Docket No. 99902052

SUBJECT: NuScale Power, LLC Submittal of Topical Report TR-121172, Revision 1, on behalf of CFPP, LLC for the “Carbon Free Power Project (CFPP) Nuclear Quality Assurance Program Description,” Revision 003 (Nonproprietary)

Licensing Topical Report

Quality Assurance Program Description

Figure I.1-1
CFPP Organization

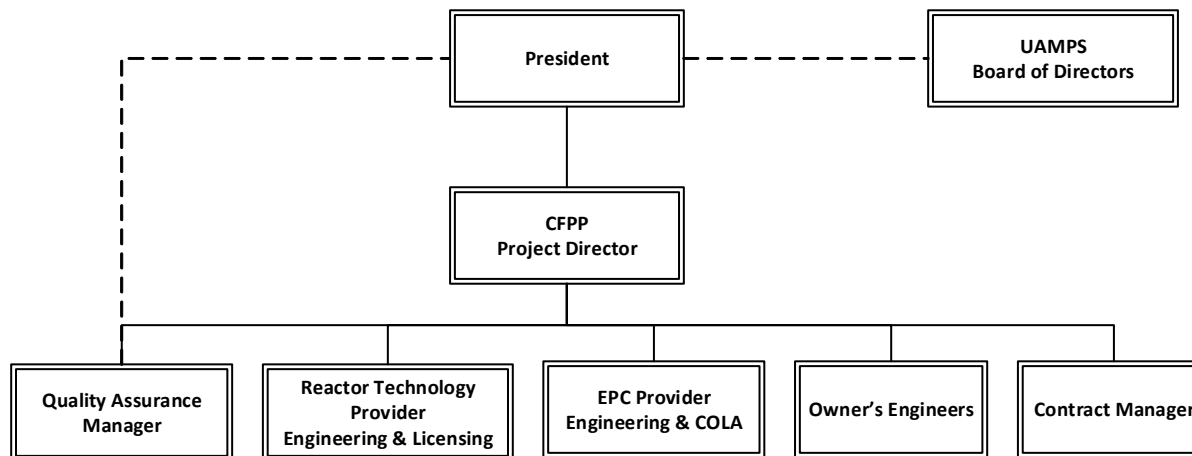
- The NRC staff referenced one SRP Section 17.5 acceptance criterion regarding a description of the periodic evaluation of significantly delegated activities and the individuals/companies performing these activities. The NRC staff understands that CFPP has contractual agreements with various entities supporting the development of its COLA and noted that this information is not in the submittal and that Figure II.1-1 in the submittal is unreadable to determine which entities support the CFPP activities.

- CFPP Response: A description of the periodic evaluation of significantly delegated activities and the companies performing these activities are provided in Section 2 Quality Assurance Program of the CFPP QAPD Revision 003. Figure II.1-1 (renumbered as Figure I.1-1) has also been revised in the enclosed CFPP QAPD Revision 003.
